***Class V Treated Water Infiltration System Application Review***

**The Cadmus Group, Inc.  
57 Water Street  
Watertown, MA 02472**

**Final Report**

**June 12, 2008**

Figure 2 Spatial Distribution of Infiltration Mound for Input Scenario 2.

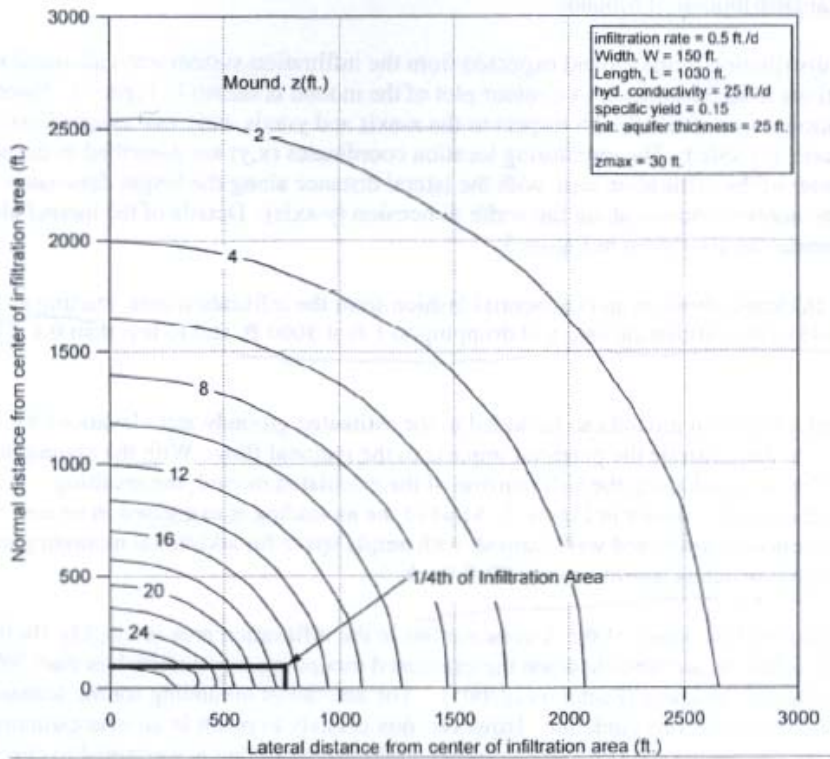
Additionally the shape of the groundwater mounds is compared. The original models provide for contours of the mound for Scenario 2. The rectangular area is 150 x 1027 feet. There appears to be a slight error in F&VD Figure 2. The ¼ patch rectangle should be 75 x 514 feet, but appears to be approximately 75 x 750 feet.

**Comparison of F&VD analytical solution and AQTESOLV predicted mounding.**

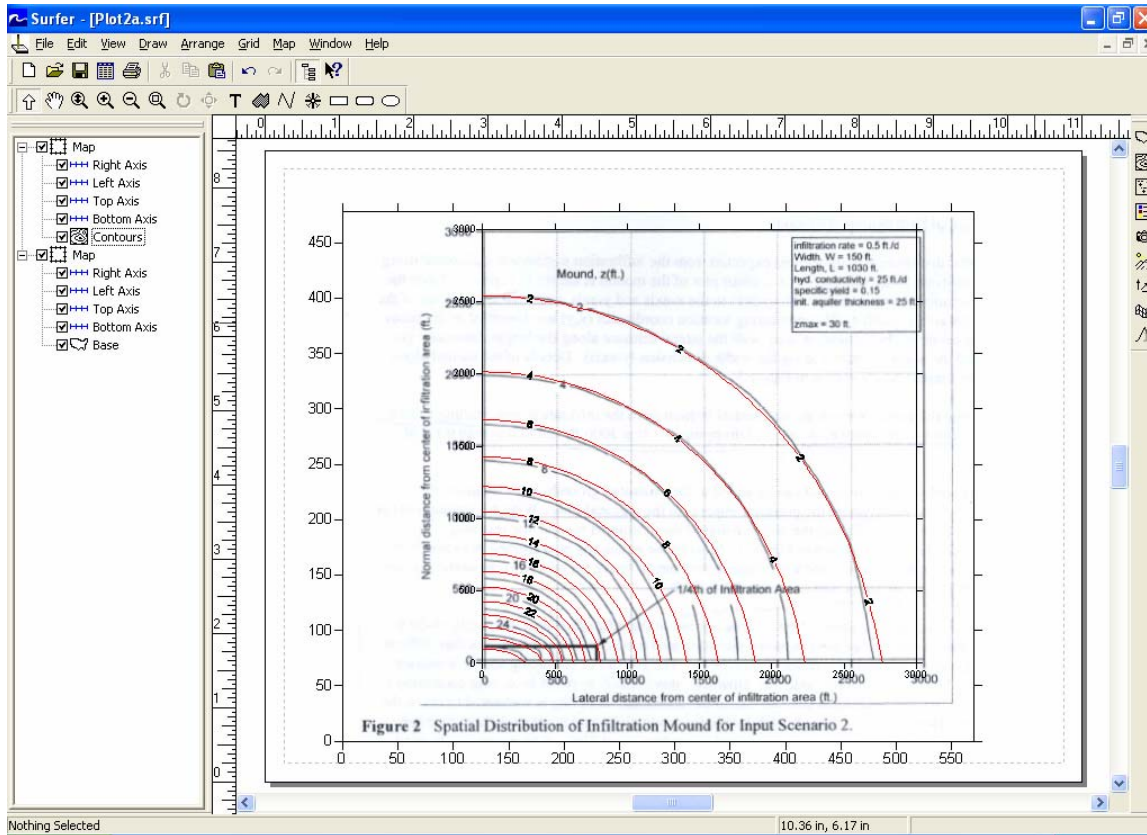
Using AQTESOLV (shown in red), similar results are obtained as shown below. Except for differences resulting from the contouring approaches used, the results are very similar. This indicates that the two sets of calculation results are consistent and probably correct.

**Figure 2. Conceptual Hydrogeological Cross Section C-C'. From Foth and Van Dyke, 2006**

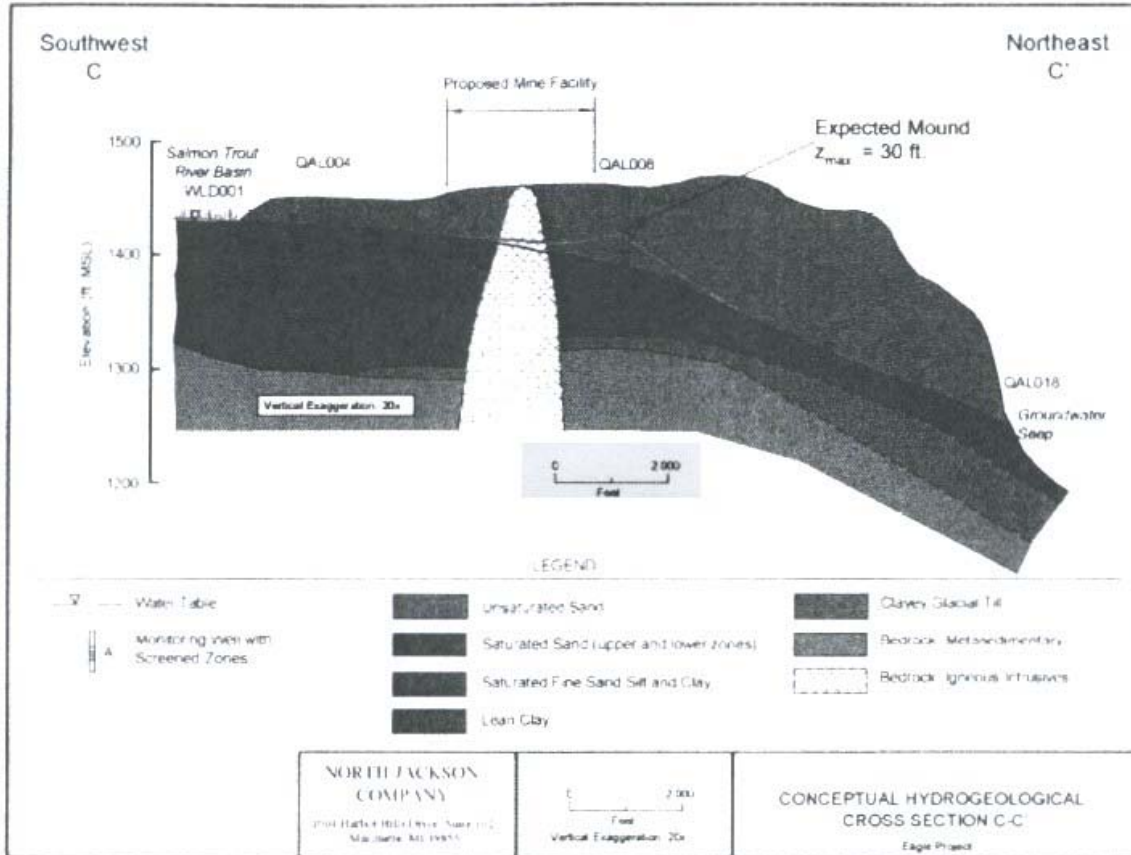
Using AQTESOLV, the analytical model can be further extended to address the effects of boundary conditions. The F&VD analytical solution assumes infinite boundary conditions, however, the Peridotite dike intrusion is located approximately 1,200 feet upgradient of the recharge site and is a potential localized flow barrier.

**Figure 3** Detail of Infiltration Mound with Normal Distance (y-dimension) for Input Scenario 2.

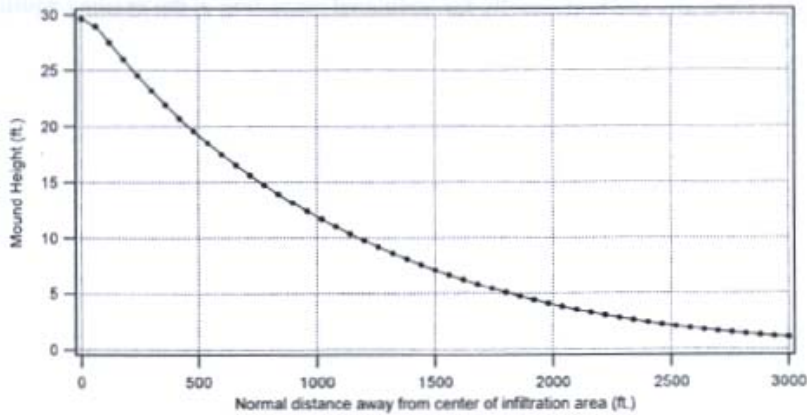
The dike appears to be located at a point where the predicted mounding is about 9-10 feet as shown in Figure 3 by F&VD.

### Comparison of F&VD and AQTESOLV with no-flow boundary

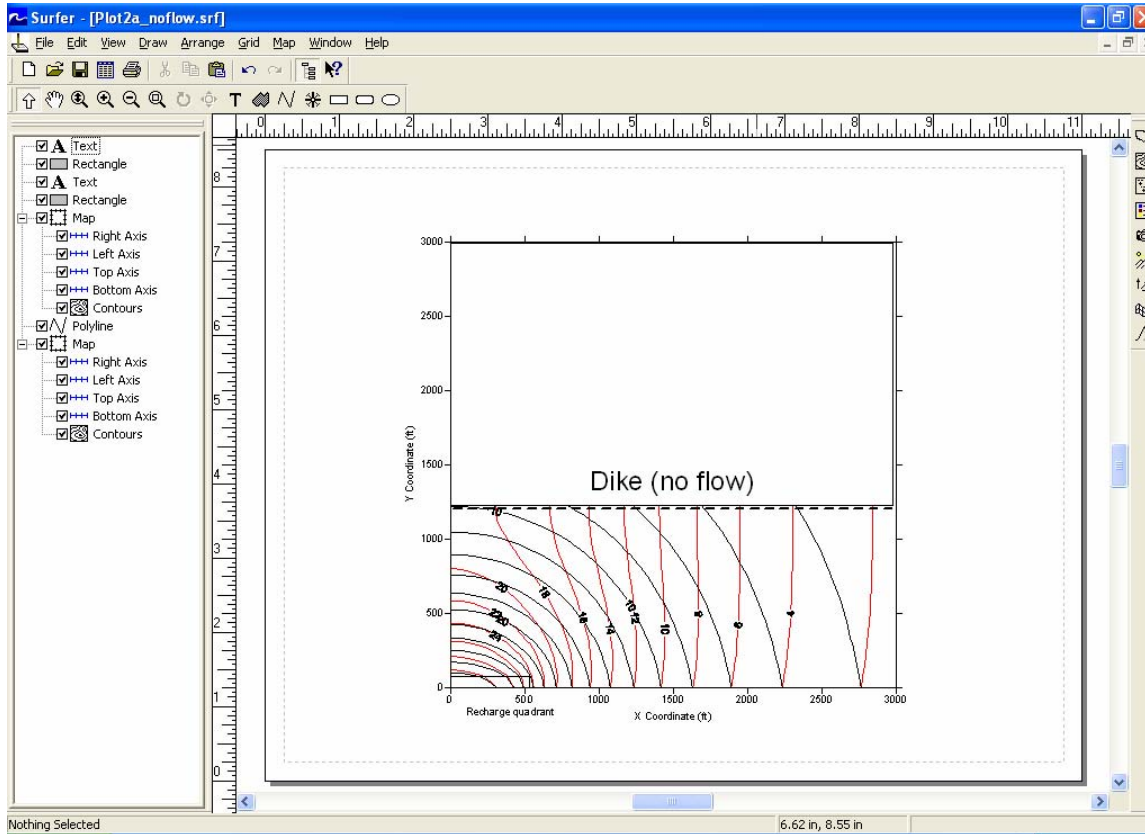
When the dike is added to the model, the mound near the dike increases from 10 to 19 feet although the maximum mound beneath the center of the infiltration zone is nearly unchanged.

This indicates that incorporation of the dike has no significant effect on the height of the mound beneath the infiltration site, but may locally increase mounding in the vicinity of the actual dike.
